Avolites Ltd. Engineering Change Notice

TitleMobile Fader noise and ref Voltage change **ECN Number**ECN-0189 &190

Reason for ECN Occasional fader noise
Special Parts required Kit 8002-9187 consisting off

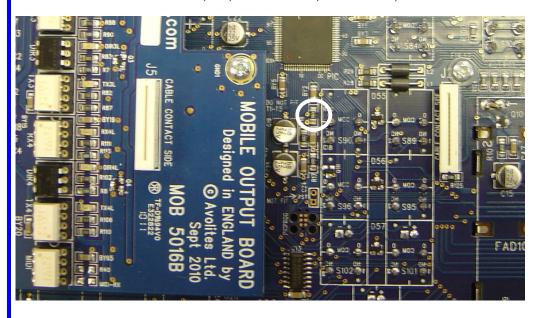
3. Remove the 6 Torx screws (circled below), and remove the cover, (The leg does not have to be removed)

4. Locate and remove R30 (47R) and fit a 75R..(Circled below)

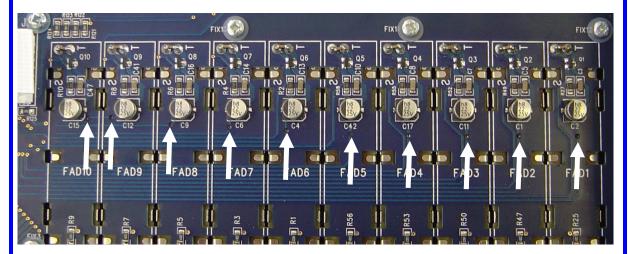
Cut tracks at the 10 points shown in the photograph (Cut at tip of the arrows shown below).

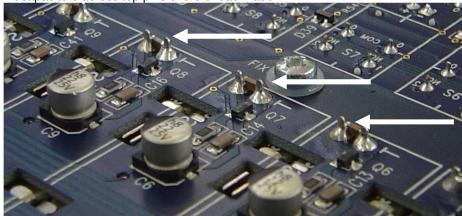
Fit capacitors across top pins of the of each fader

All 10 capacitors fitted
